# BENT GRASS EAST COMMERCIAL FILING 3

## EL PASO COUNTY, COLORADO PRELIMINARY PLAN

#### COVER SHEET

PCD Filing No.:  
SP-20-010

ADJACENT PROPERTY  
OWNERS AND TRACT  
MAP

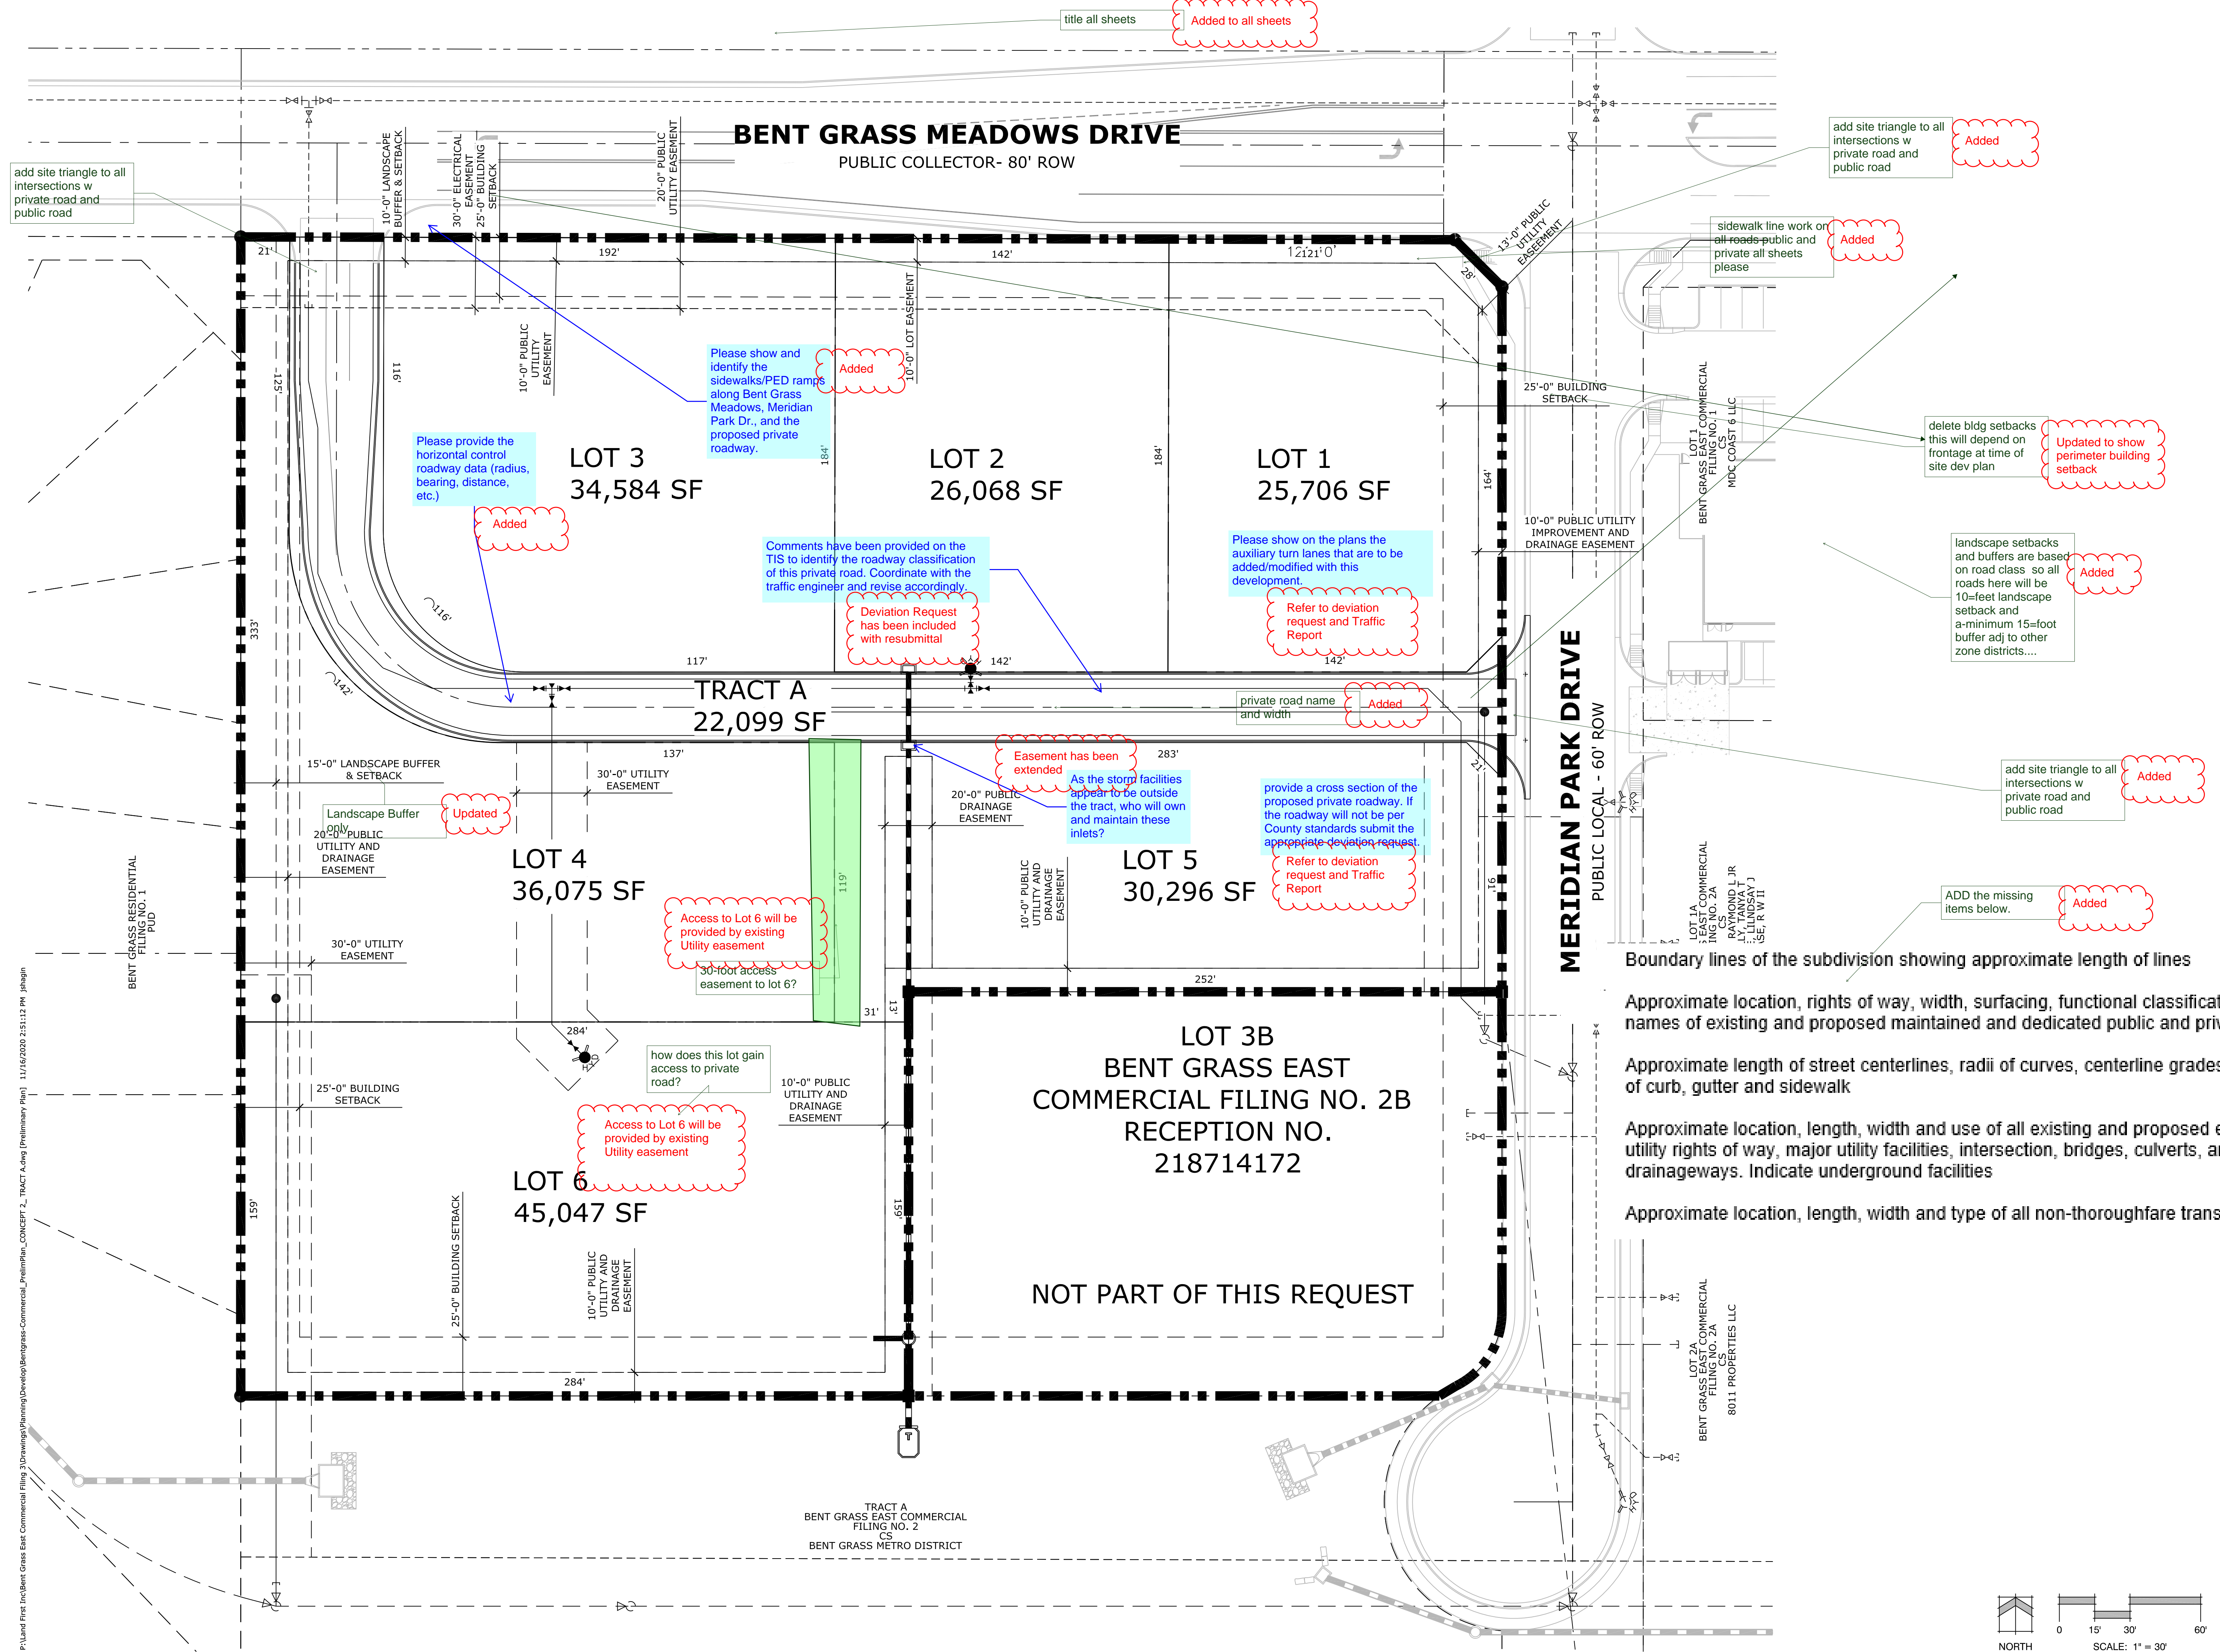
Name & address of property owners, within, surrounded by, and adjacent to the subdivision including identification of all platted subdivisions by name

Updated to reflect private road,  
utility and drainage use

Updated to Bent  
Grass Market View

PRELIMINARY GRADING PLAN

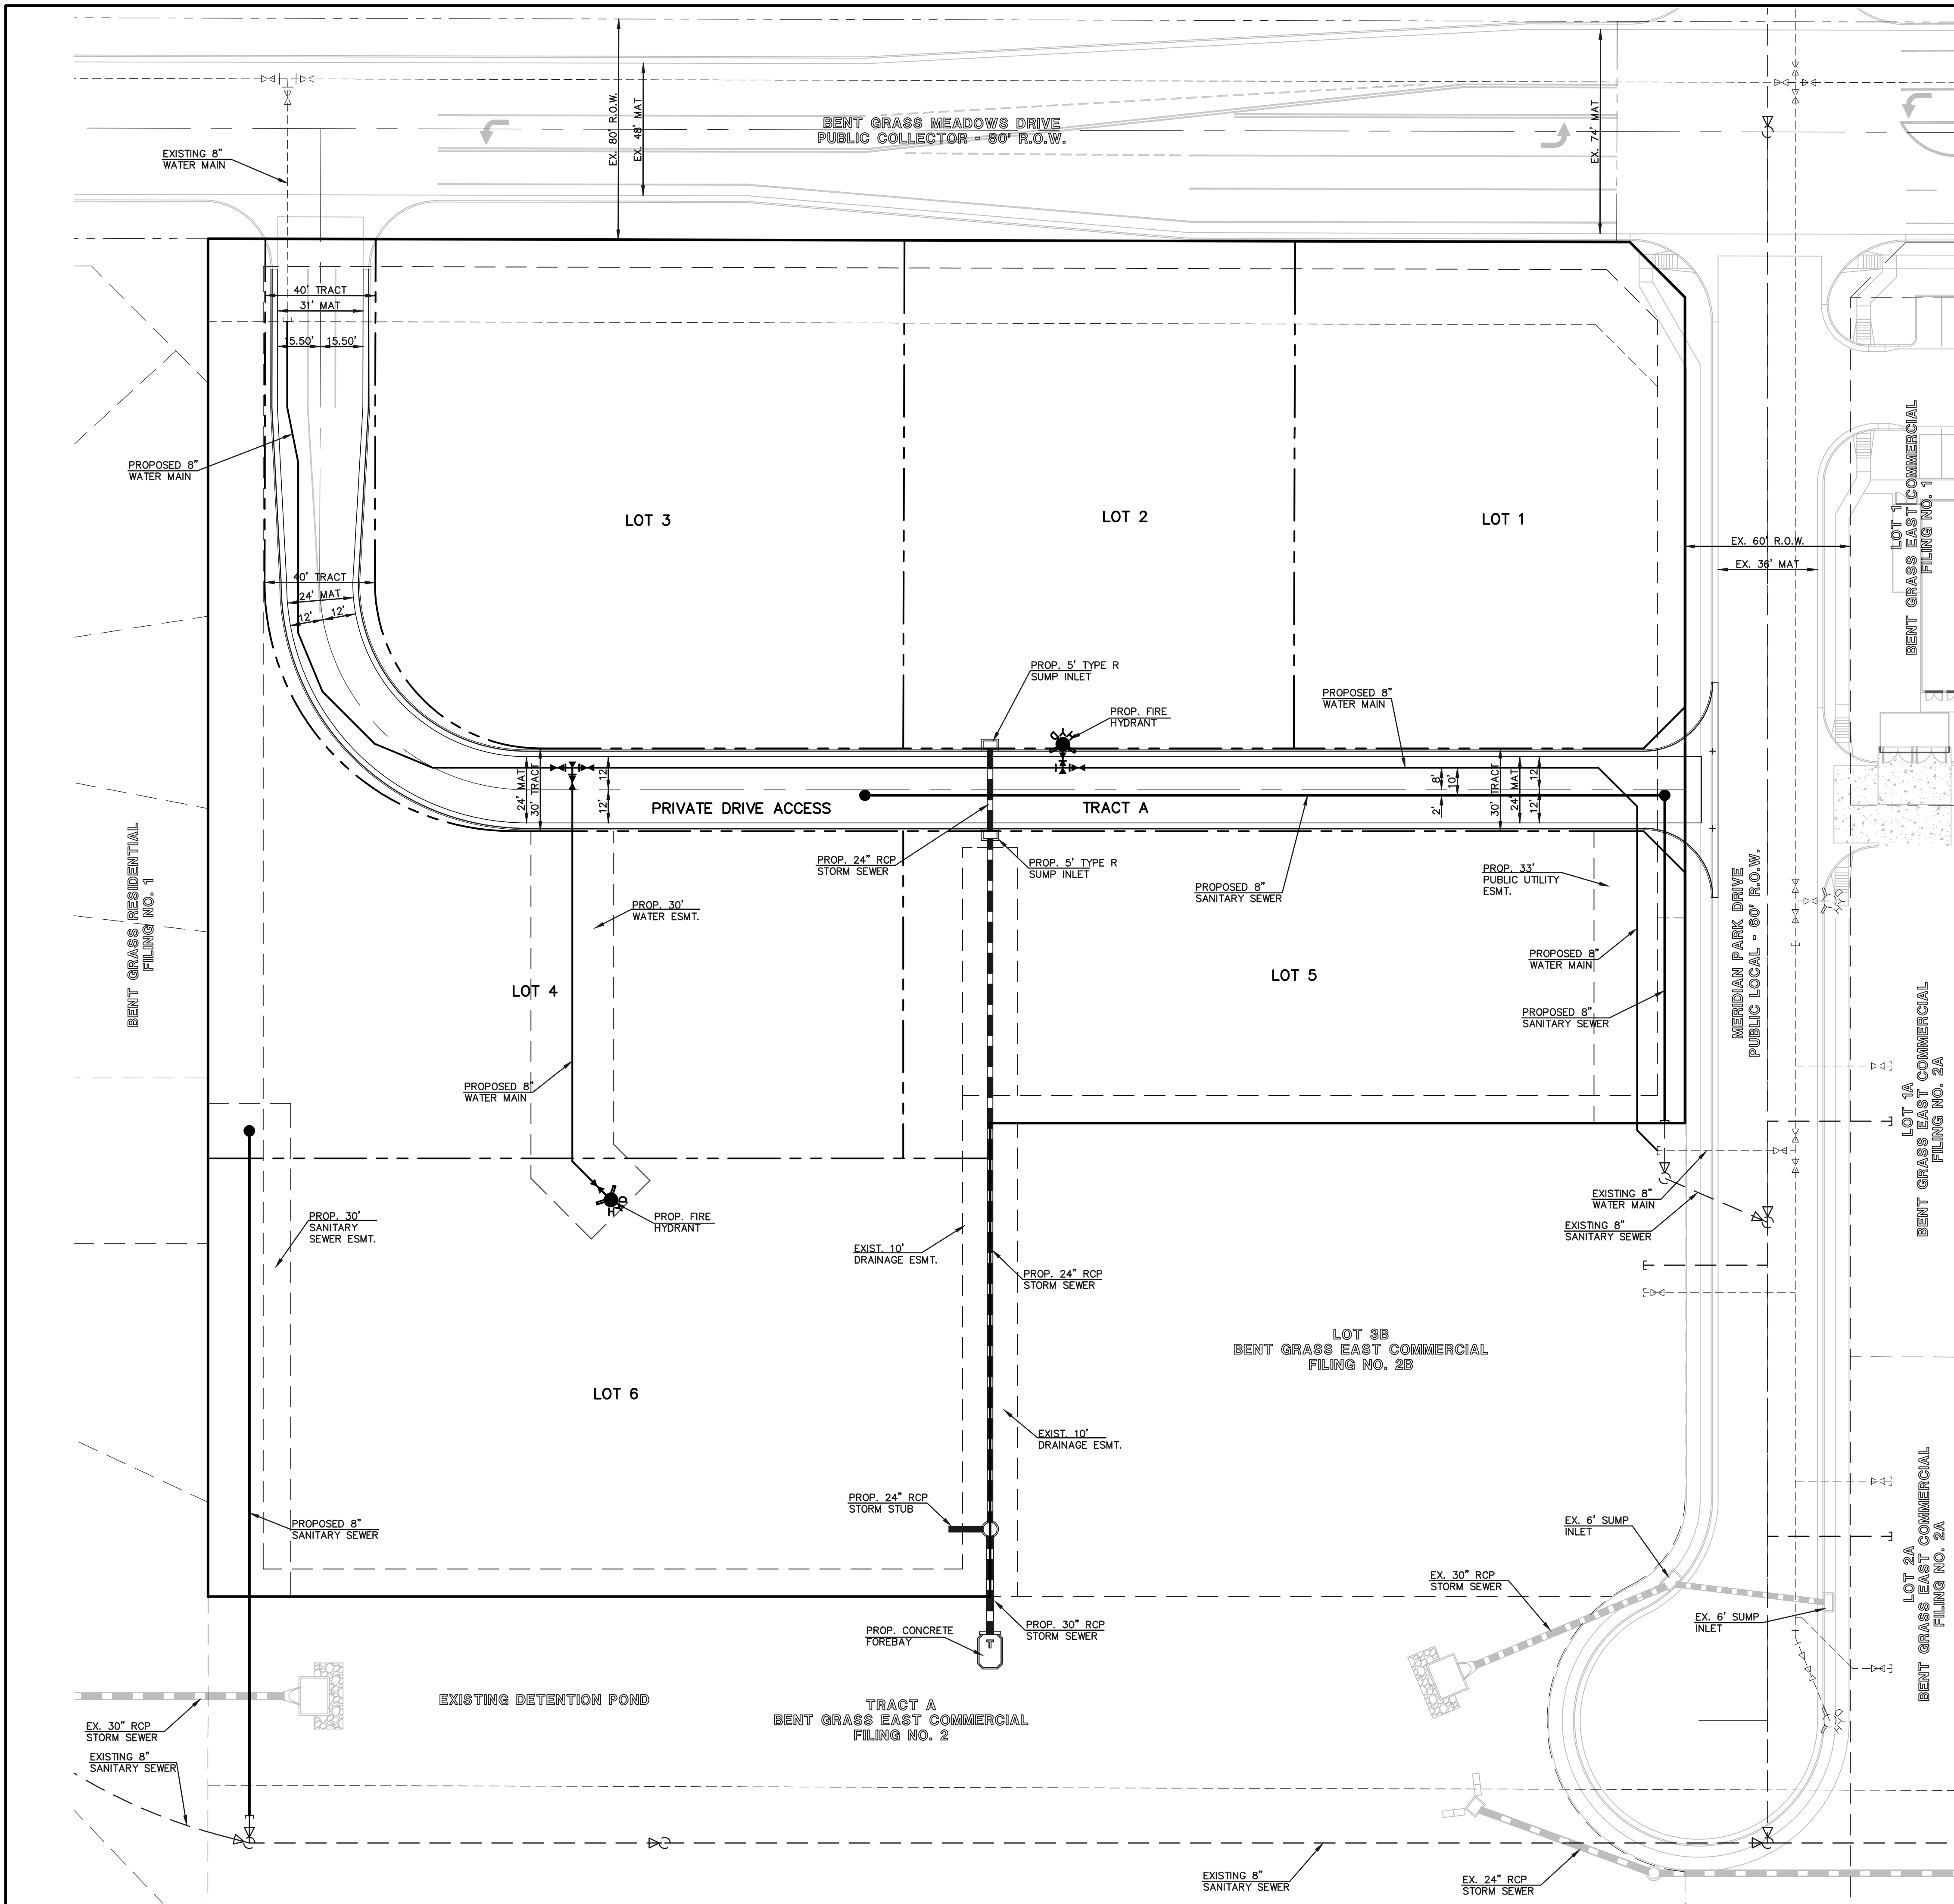
Please label the proposed storm sewers as private

Make a note that this pond (and the existing inlet and outlet structures) was originally constructed with Bent Grass Residential Filing No. 1 (SF1412).

Added

LANDSCAPE  
NOTES AND  
DETAILS

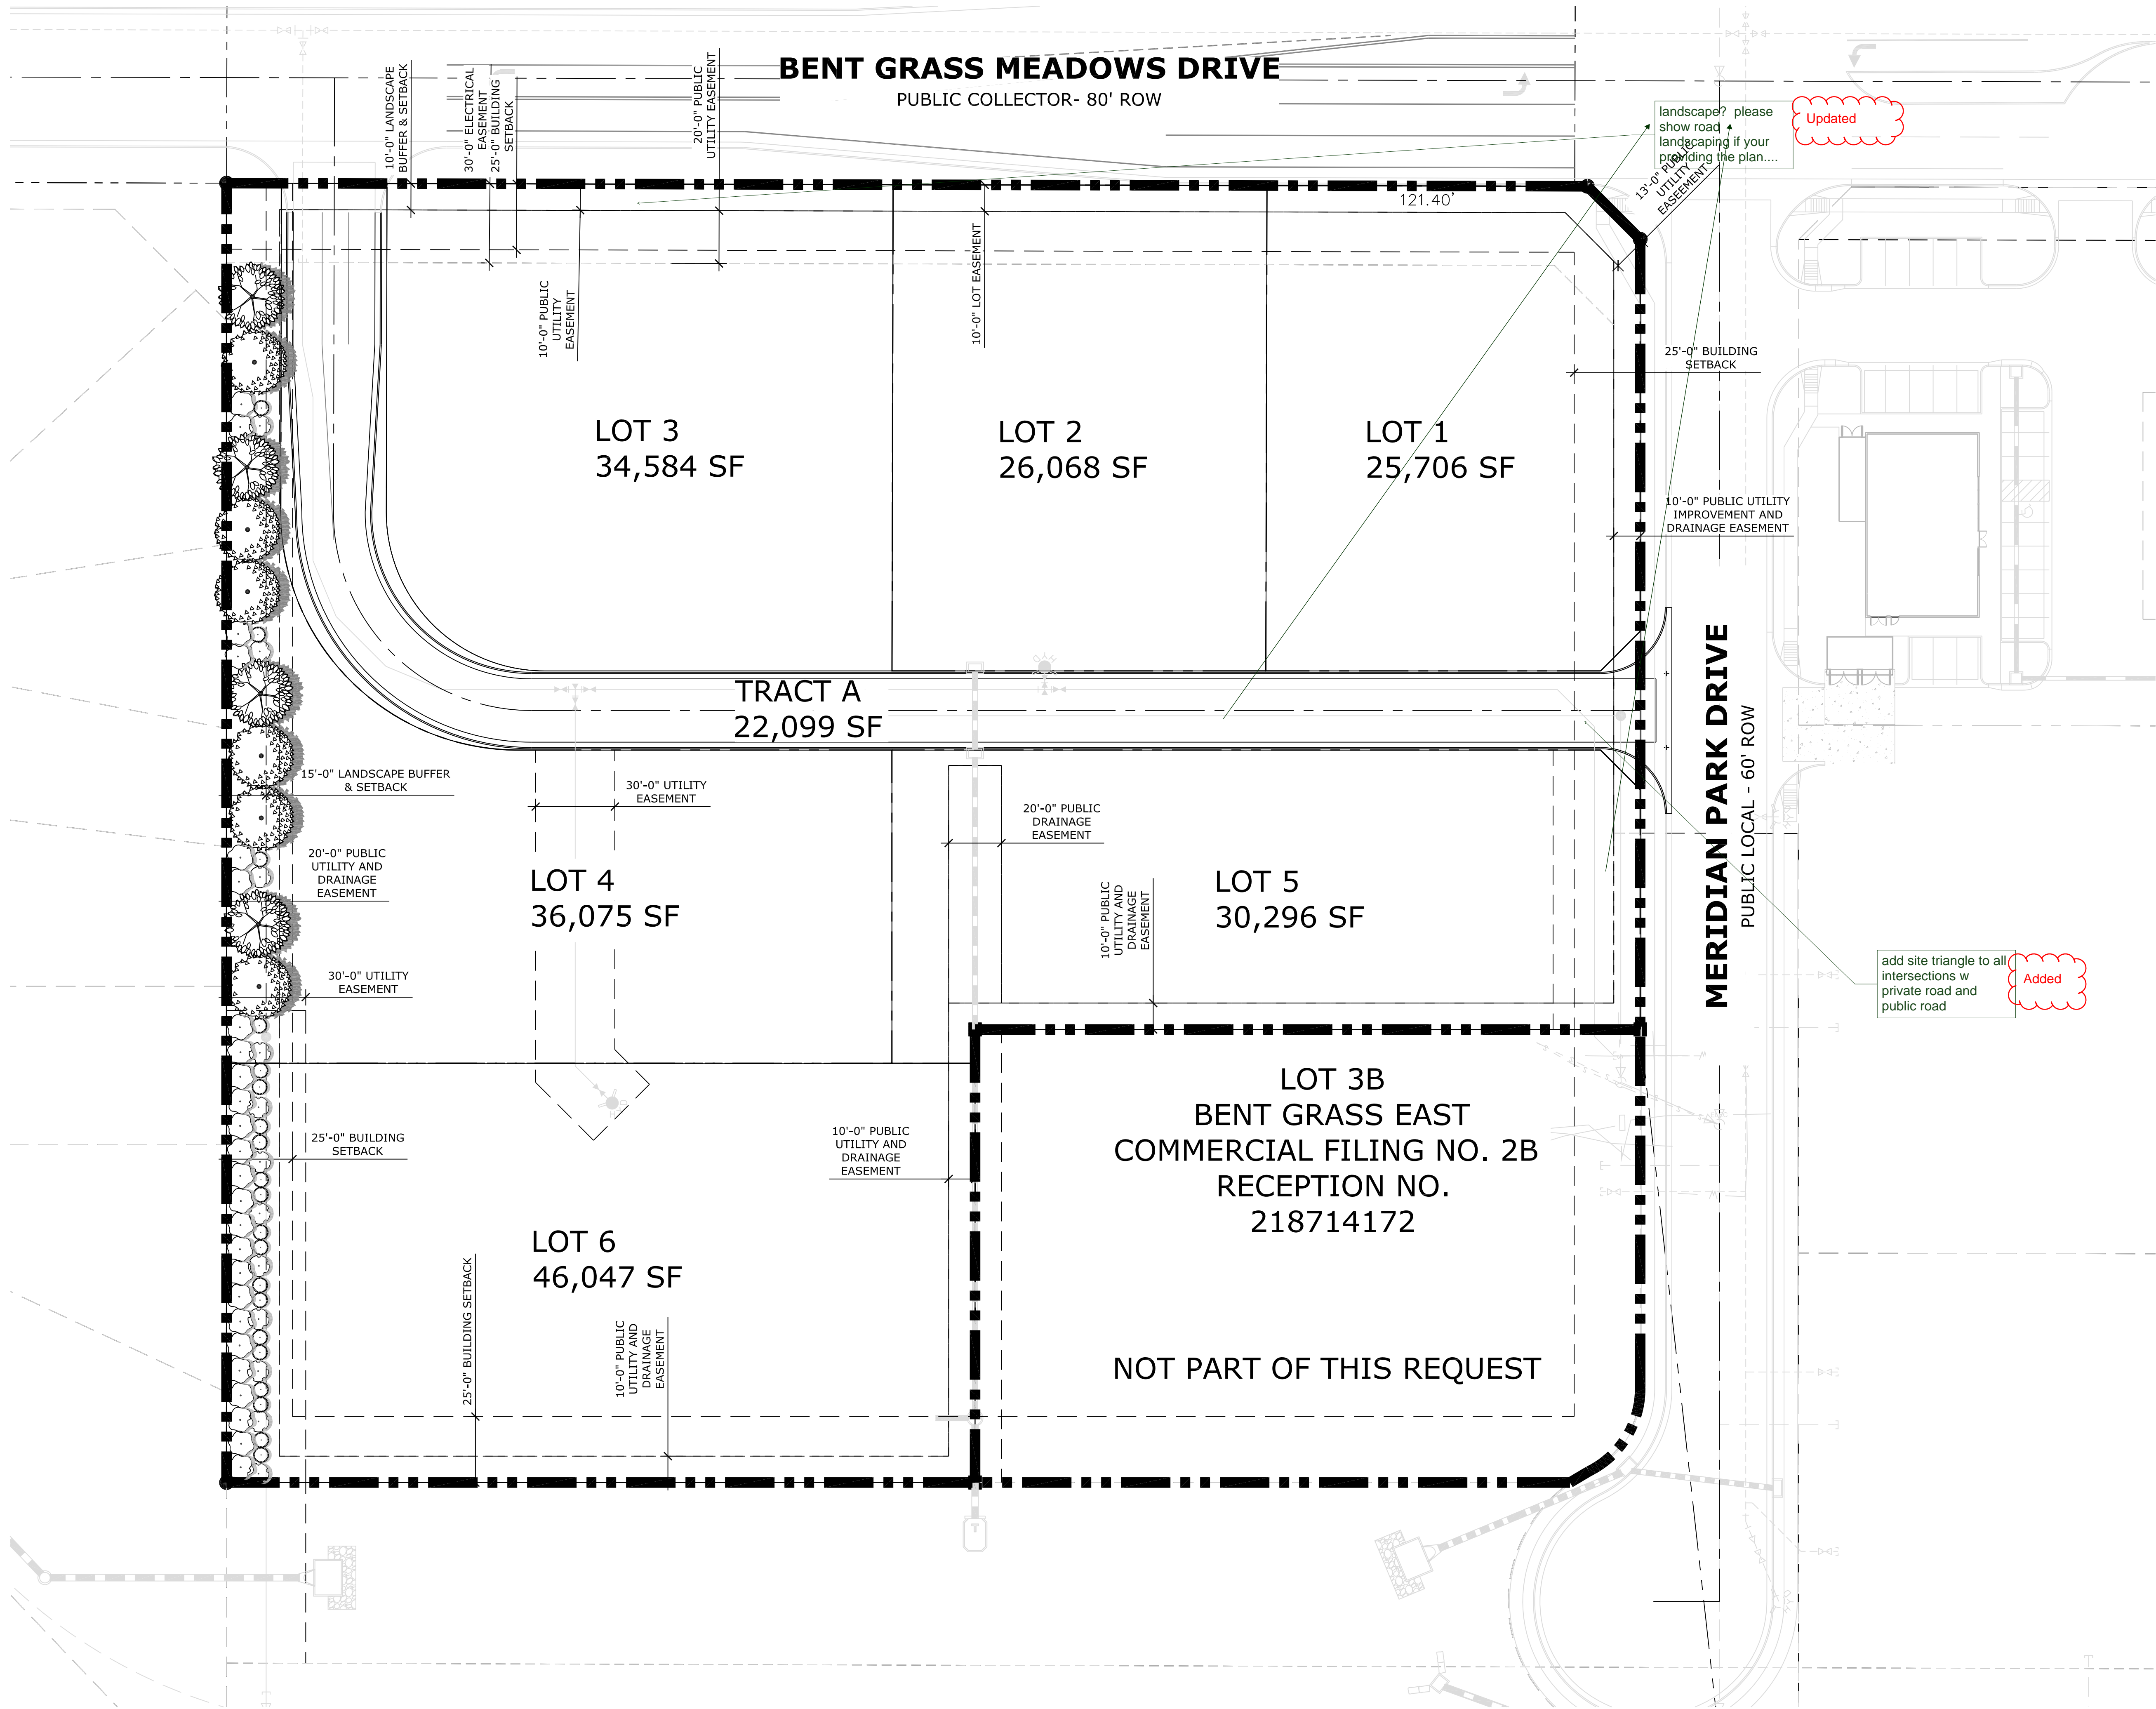
Meridan Park and private road require 10-landscape setbacks.. Do you intend to include the street landscapes and buffers as a requirement for the developer? Or is this plan for all lots to follow? what is the intent with this as it is CR zoning....

site specific lot landscape is required with Site dev plans...ADD note to this plan

please update to meet Code

Addressed

Addressed

Updated

Buffer has been added
